From: Wade, Lowell
To: ["calving@jdsmining.ca"](mailto:calving@jdsmining.ca); ["Doug"](#); ["jerryg@jdsmining.ca"](mailto:jerryg@jdsmining.ca); ["Greg Blaylock"](#); ["Nick Stoneberger"](#); ["Kevin Oakes"](#)
Cc: [Rykaart, Maritz](#); [Bay, Hope](#)
Subject: Field Directive Number: Roberts-Bay-1
Date: Monday, May 09, 2011 8:05:00 AM
Attachments: [Roberts Bay-1 Site Instruction.pdf](#)
[image001.png](#)

Roberts Bay-1

Hope Bay 2011 Construction Scope

Roberts Bay Tank Farm

Airstrip Area approved for expansion with RBTF ROQ.

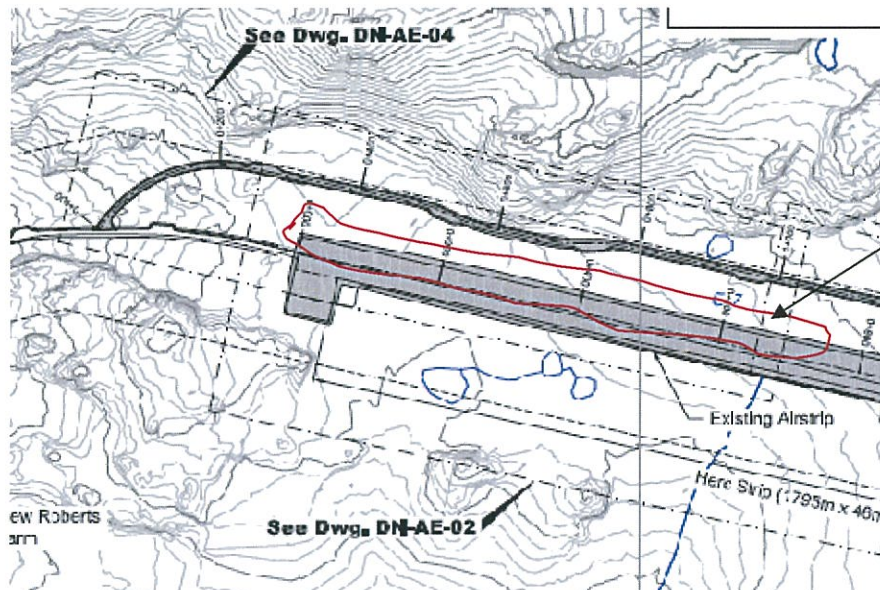
2. EPCM has approved placement of blasted ROQ at the north end of the airstrip as per the airstrip IFR drawings. It should be noted that to date SRK has not received comments back on the IFR drawings, and we understand those comments are not ready to be submitted to SRK. IFC drawings can therefore not be prepared at this time. Technically SRK has no issue with this Site Instruction; however, HBML must realize that proceeding with construction on IFR drawings is a breach of Newmont protocol established for this project.
